New Jersey Attorney General Peter C. Harvey

Proposed National Emission Standards for Hazardous Air Pollutants; and, in the Alternative, Proposed Standards of Performance for New and Existing Stationary Sources: Electric Utility Steam Generating Units; Proposed Rule

Docket No. OAR-2002-0056

June 28, 2004

Figure 1

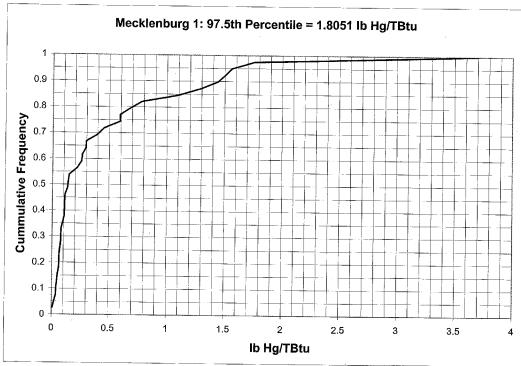
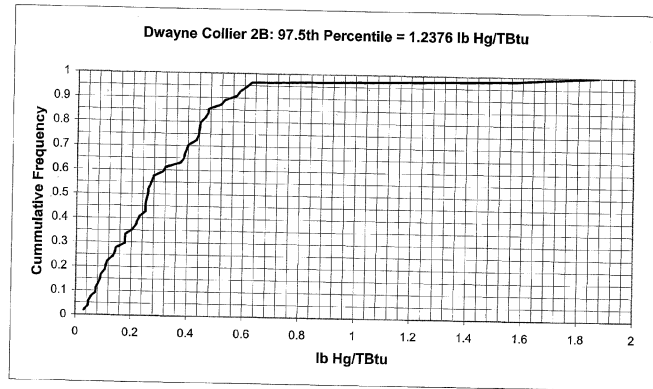
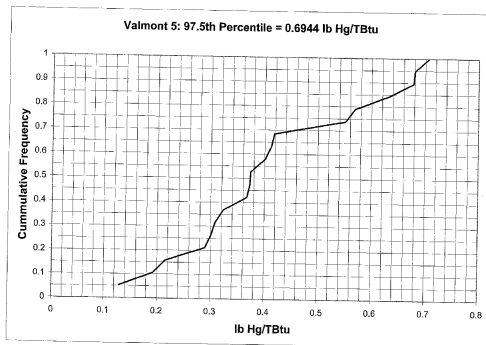
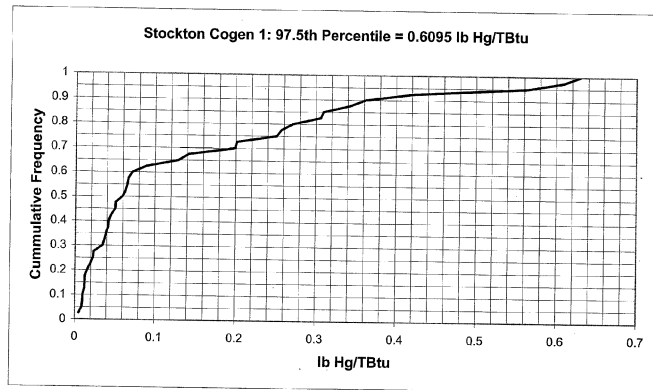
EPA's erroneous method, which came from industry consultants who developed and promoted it,⁷ is illustrated here for the bituminous subcategory but is similar for all five subcategories. Figures 1-4 show the four cumulative frequency distributions for the best-performing bituminous sources, as copied from the EPA docket.⁸ These four independent probabilistic distributions, provided by EPA, provide the starting-point for EPA's incorrect calculations and also for our own correct approach. What EPA needs to do is *combine these four distributions into a single distribution* that represents the behavior of the average. This is what the law requires. EPA could then set its emissions limit at an appropriate percentile on this combined distribution.

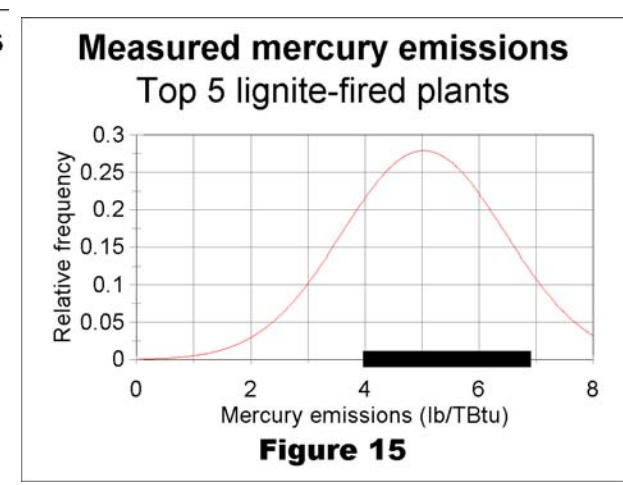
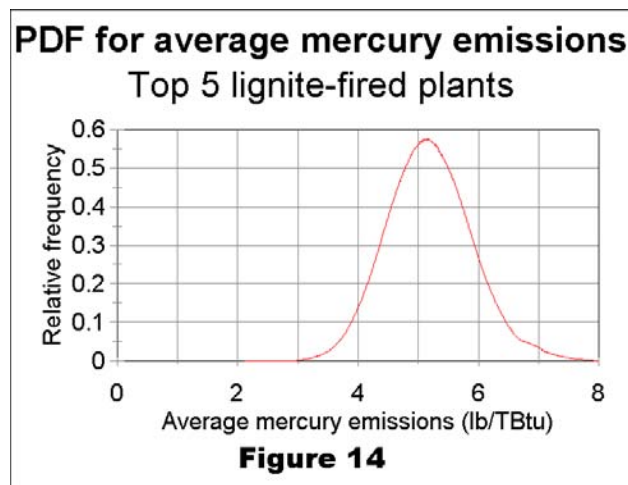
Figures 10 and 11 show the PDF and the actual test data, respectively, for the best-performing bituminous plants. Figure 10 shows the PDF obtained from EPA's variability analysis, as described above. It has a mean of about 0.34 and a median of about 0.28 lb/TBtu. The curve in Figure 11 shows the normal distribution that represents the emission testing at the best-performing bituminous plants.¹⁶ The black bar along the x-axis of Figure 11 shows the range of actual measured emissions (the four measured values were 0.1062, 0.1074, 0.1268, and 0.1316 lb/TBtu) from which EPA calculated a mean of 0.118 and a standard deviation of 0.0131 lb/TBtu.¹⁷ Comparison of Figures 10 and 11 shows that these two graphs are very different from each other, even though both nominally represent the average mercury emissions from the best-performing bituminous plants. (One represents the average emissions predicted by EPA's variability analysis; the other shows actual emissions testing data collected by EPA.) The curve in Figure 10 should overlap both the curve and the data range in Figure 11, but it does not. The two curves are poorly correlated and almost mutually exclusive. The measured emissions average in Figure 11 (0.118 lb/TBtu) lies at the far left side, at about the 3rd percentile, of the predicted emissions average in Figure 10. This makes no sense; it violates the principle of a central tendency and implies that something is seriously wrong with EPA's cumulative frequency distributions and underlying variability analyses in the bituminous subcategory.

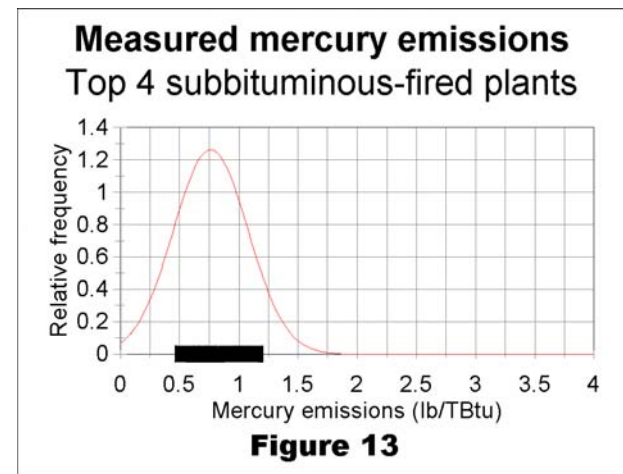
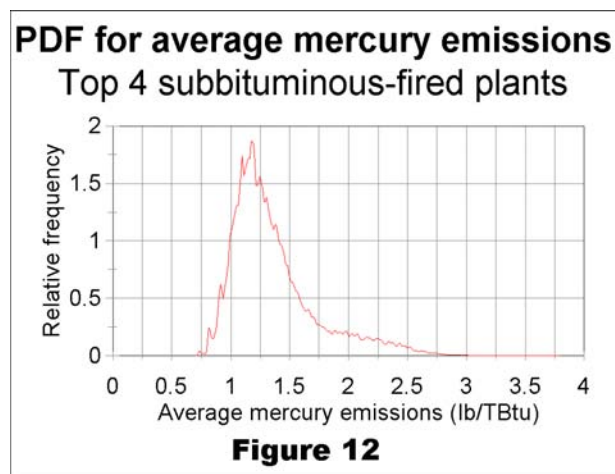
Figures 12 and 13 show the PDF and the actual test data, respectively, for the best-performing subbituminous plants. Figure 12 shows the PDF obtained from EPA's variability analysis, as described above. It has a mean of about 1.32 and a median of about 1.26 lb/TBtu. The curve in Figure 13 shows the normal distribution that represents the emission testing at the best-performing subbituminous plants.¹⁸ The black bar along the x-axis of Figure 13 shows the range of actual measured emissions (the four measured values were 0.4606, 0.6633, 0.7248, and 1.2066 lb/TBtu) from which EPA calculated a mean of 0.738 [or 0.7638] and a standard deviation of

0.316 lb/TBtu.¹⁹ Comparison of Figures 12 and 13 shows that these two graphs are very different from each other, even though both nominally represent the average mercury emissions from the best-performing subbituminous plants. (One represents the average emissions predicted by EPA's variability analysis; the other shows actual emissions testing data collected by EPA.) The curve in Figure 12 should overlap both the curve and the data range in Figure 13, but it does not. The two curves are very poorly correlated. The measured emissions average in Figure 13 (0.738 or 0.7638 lb/TBtu) lies at the far left side, below the 1st percentile, of the predicted emissions average in Figure 12. This makes no sense; it violates the principle of a central tendency and implies that something is seriously wrong with EPA's cumulative frequency distributions and underlying variability analyses in the subbituminous subcategory.

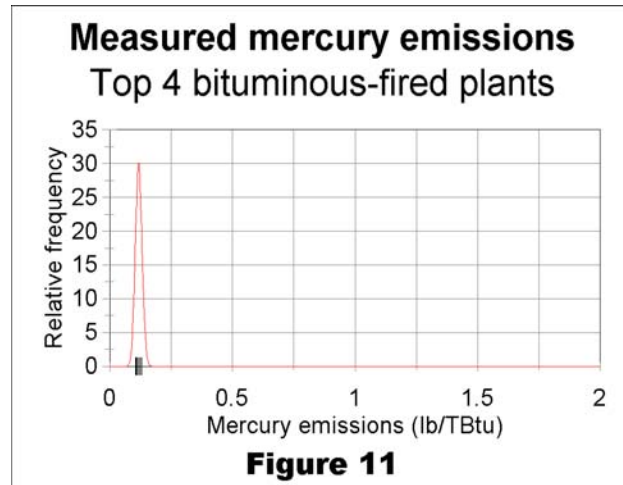
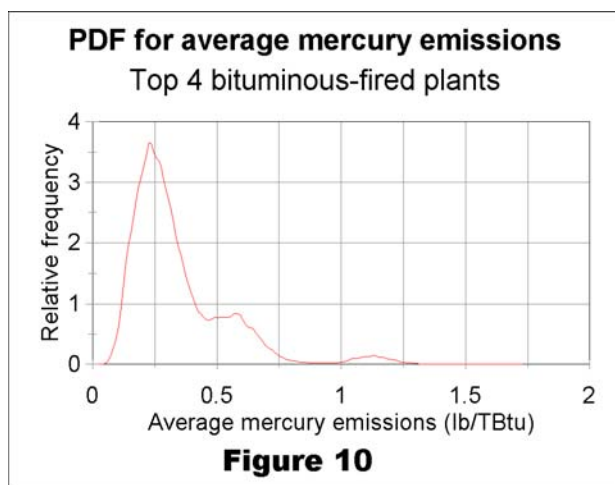
Figures 14 and 15 show the PDF and the actual test data, respectively, for the best-performing lignite plants. Figure 14 shows the PDF obtained from EPA's variability analysis, as described above. Its mean and median are both about 5.2 lb/TBtu. The curve in Figure 15 shows the normal distribution that represents the emission testing at the best-performing lignite plants.²⁰ The black bar along the x-axis of Figure 15 shows the range of actual measured emissions (the five measured values were 3.977, 4.004, 4.023, 6.252, and 6.902 lb/TBtu) from which EPA calculated a mean of 5.032 and a standard deviation of 1.429 lb/TBtu.²¹ Comparison of Figures 14 and 15 shows that these two graphs are generally similar to each other. The mean in Figure 14 is essentially the same as the mean in Figure 15, as would be expected, since both graphs represent the average mercury emissions from the best-performing lignite plants.

Figure 16

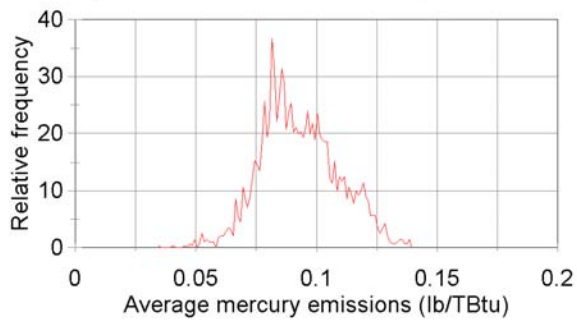
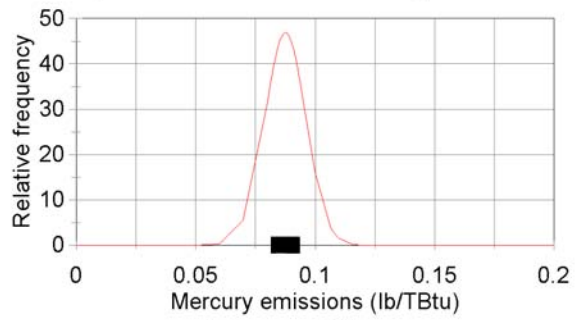
Figures 16 and 17 show the PDF and the actual test data, respectively, for the best-performing coal-refuse plants. Figure 16 shows the PDF obtained from EPA's variability analysis, as described above. Its mean and median are both about 0.09 lb/TBtu. The curve in Figure 17 shows the normal distribution that approximately represents the emission testing at the best-performing coal-refuse plants.²² The black bar along the x-axis of Figure 17 shows the range of

actual measured emissions (the two measured values were 0.0816 and 0.0936 lb/TBtu) from which EPA calculated a mean of 0.088 and a standard deviation of 0.0085 lb/TBtu.²³ Comparison of Figures 16 and 17 shows that these two graphs are generally similar to each other. The mean in Figure 16 is similar to the mean in Figure 17, as would be expected, since both graphs represent the average mercury emissions from the best-performing coal-refuse plants.

Figure 18

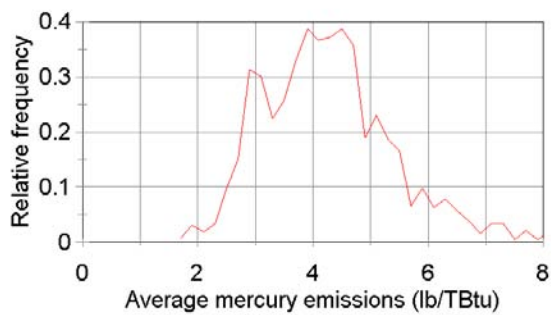
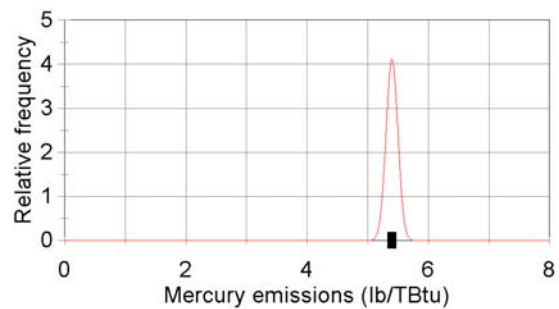
Figures 18 and 19 show the PDF and the actual test data, respectively, for the best-performing IGCC plants. Figure 18 shows the PDF obtained from EPA's variability analysis, as described above. Its mean and median are both about 4.2 lb/TBtu. The curve in Figure 19 shows the normal distribution that approximately represents the emission testing at the best-performing IGCC plants.²⁴ The black bar along the x-axis of Figure 19 shows the range of actual measured emissions (the two measured values were 5.3343 and 5.4713 lb/TBtu) from which EPA calculated a mean of 5.403 and a standard deviation of 0.097 lb/TBtu.²⁵ Comparison of Figures 18 and 19 shows that these two graphs are somewhat similar to each other. The curve in Figure 18 overlaps the mean and test data in Figure 19, as it should. The means are not as well-aligned as in the lignite and coal-refuse subcategories, but not so poorly aligned as in the bituminous and subbituminous subcategories.
